# Discrepancy in OMAouter and TDECQ penalty computation for link budget

Addressing comments #1, 4 of IEEE 802.3 dj draft 2.3

Laurent Alloin, Eric Maniloff, Amitkumar Mahadevan  
Ciena

Figure 180–8—Example power levels  $P_0$  and  $P_3$  from PRBS13Q test pattern

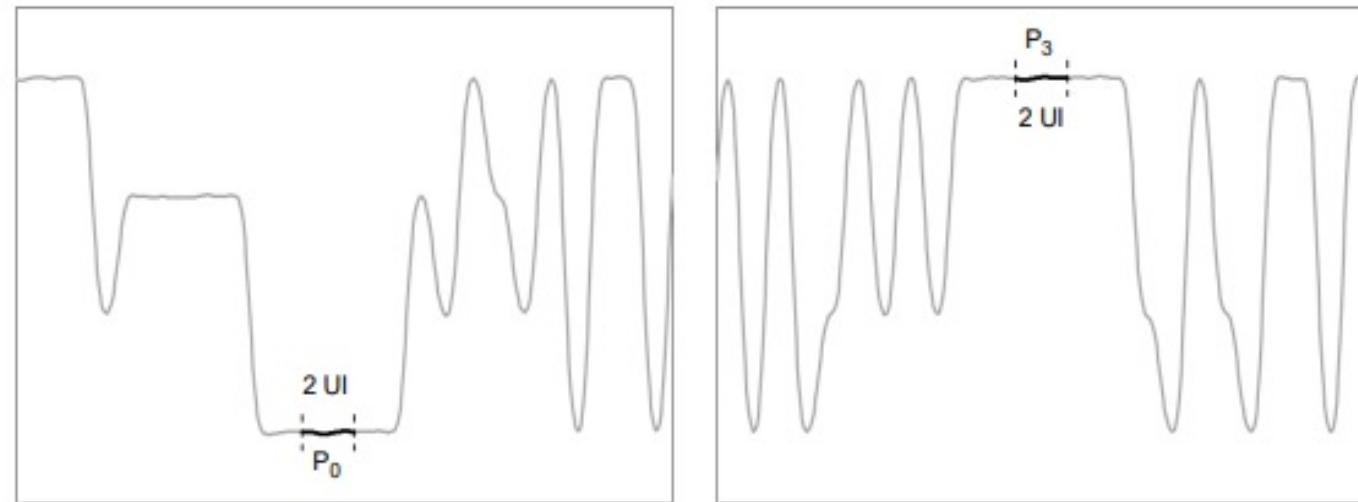
As noted in previous comments, the illustration of the signal in Figure 180-8 does not match this statement; the signal in the figure is fully equalized. Indeed, in a non-equalized signal, there will likely be no flat region in a 6-UI run (noting that the reference equalizer is longer).

In another comment I am suggesting that the reference equalizer should be normalized to have  $c(0)=1$ . With this modification, the nominal 0 and 3 levels will be the same before and after the equalizer, but the eye diagram will be open, and thus OMA\_outer will be measurable at the equalizer output on flat regions. This will also match the illustration in Figure 180-8.

Change "at the output of the reference receiver defined in 180.9.2" to "at the output of the reference equalizer defined in 180.9.6.3".

Figure 180-5—Transmitter  $OMA_{outer}$  each lane versus  $\max(TECQ, TDECQ)$  and receiver sensitivity ( $OMA_{outer}$ ) each lane versus TECQ

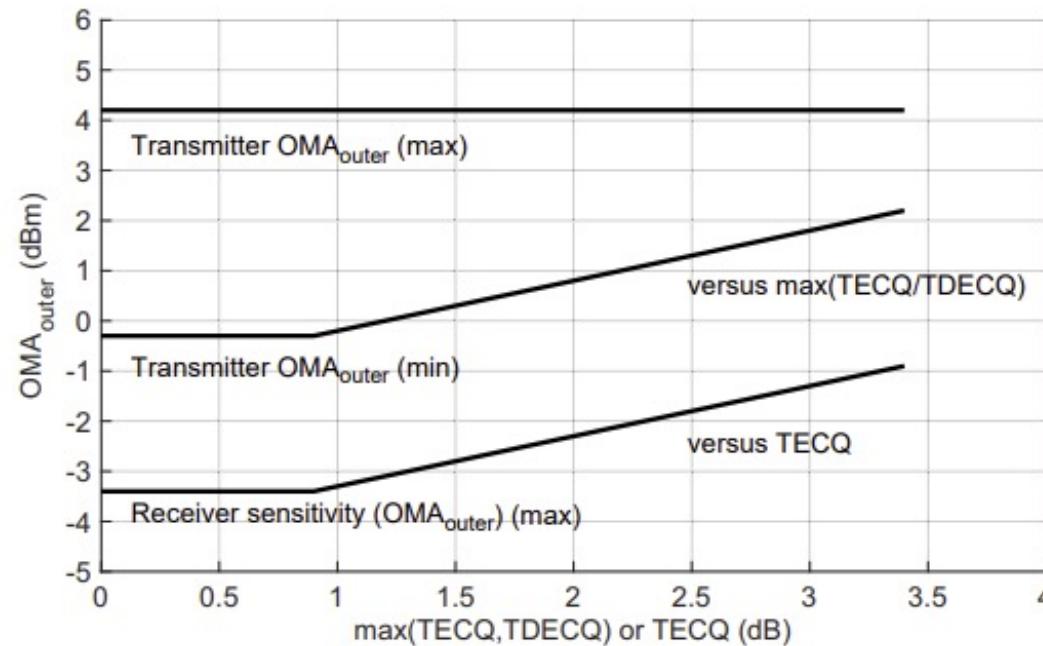
For Link budget calculation, it is ambiguous whether the  $OMA_{outer}$  considered is measured “before the reference equalizer” or “on the equalized signal”

Since  $OMA_{outer}$  -TDECQ is understood as the “usable” OMA of the TX as seen by the reference RX, both quantities need to be defined consistently.

Figure 180-11—Illustration of the TDECQ measurement

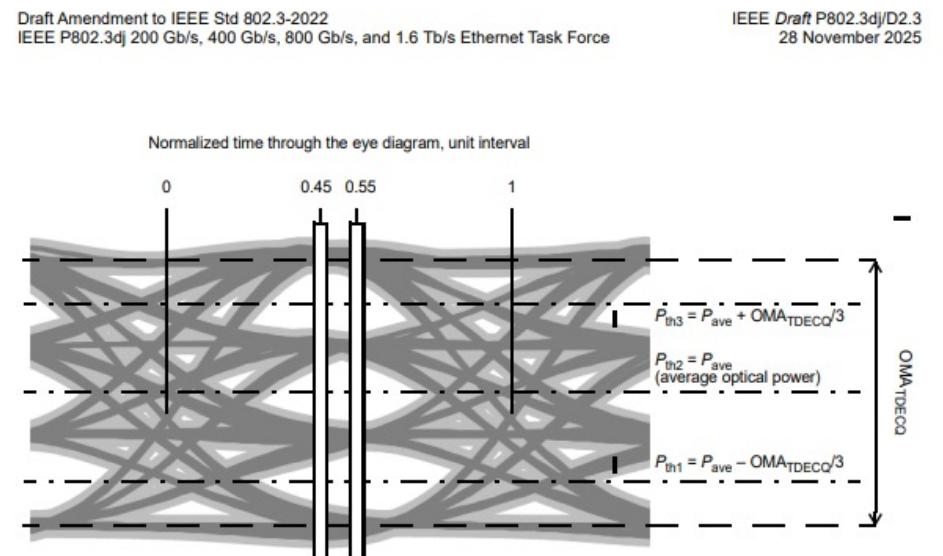
1. Keep  $OMA_{TDECQ}$  as defined at the equalizer output (FFE+DFE), as suggested by its definition line 46 p485, and in agreement with the definition of the reference equalizer in 180.9.6.3. (i.e. point C from prior slide)

If specified accordingly, then  $OMA_{TDECQ}$  is correctly used to determine threshold levels  $P_{th1}$ ,  $P_{th2}$ ,  $P_{th3}$  (as currently in equations 180-1, 180-3, and depicted in Figure 180-11)

=> No changes !

Figure 180-11—Illustration of the TDECQ measurement

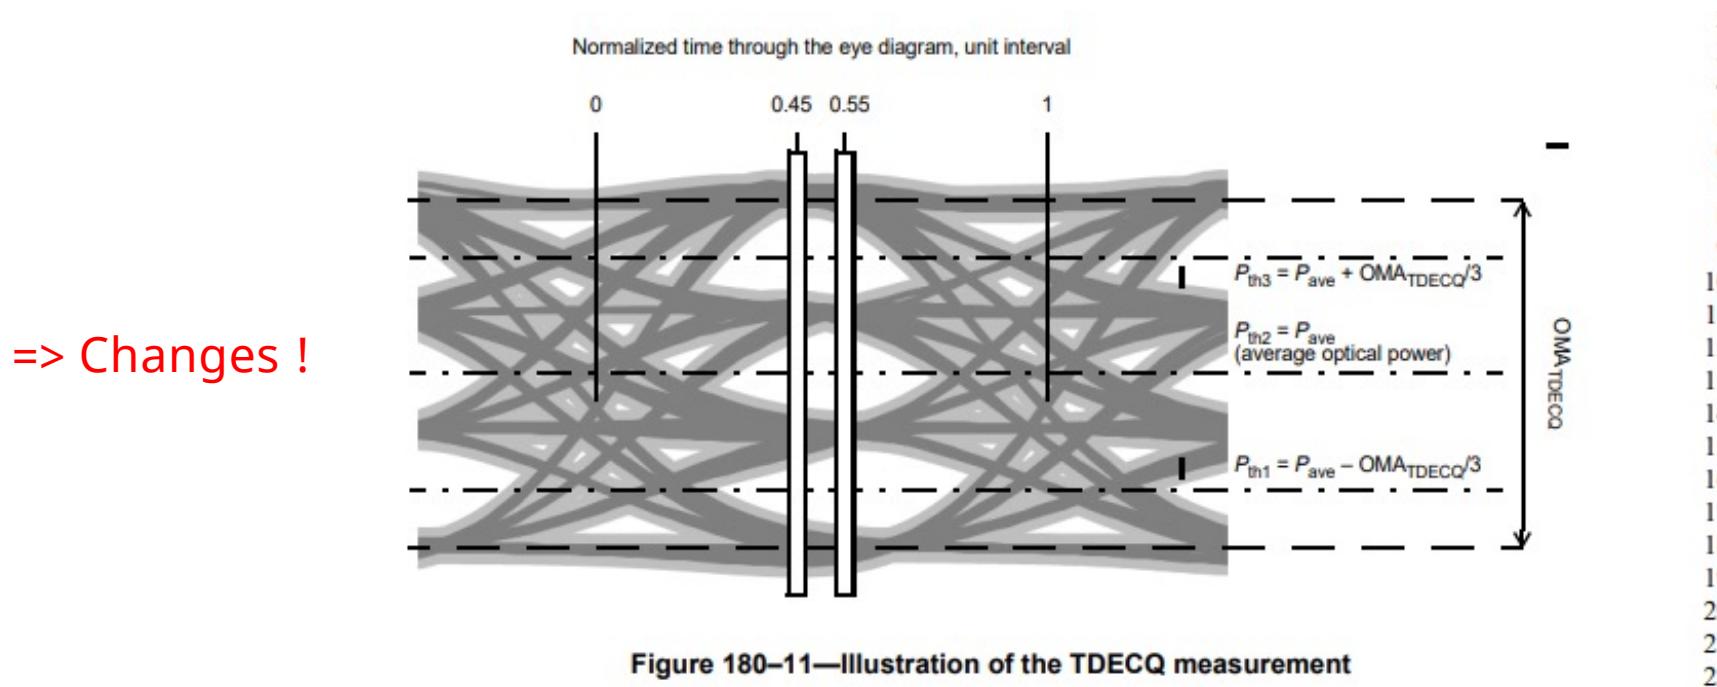
figure 180-11 with the threshold definitions in Eq 180-1/3 will have to change

And equations 180-4 thru. 180-8 needs to checked to account for the equalizer gain  $H_{eq}(f = 0) \neq 1$ , and threshold changes
